# Technical Service Information

## NISSAN RL3F01A STANZA 3-2 DOWN SHIFT CLUNK

Figure 1

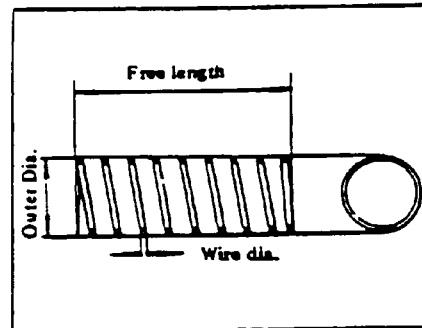
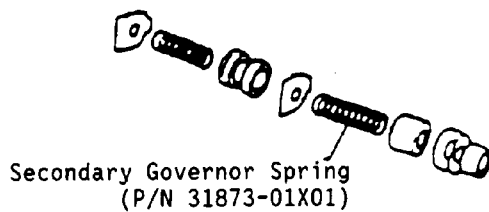
**COMPLAINT:** Stanza models exhibit a 3-2 down shift clunk.

**CORRECTION:** Install new Secondary Governor Spring, part # 31873-01X01

SPRING P/N	FREE LENGTH MM (IN)	WIRE DIA. MM (IN)	OUTER COIL DIA. MM (IN)
Former-31873-01X00	38.2 (1.504)	0.8 (0.031)	10.8 (0.425)
New -31873-01X01	41.0 (1.614)	0.8 (0.031)	10.8 (0.425)
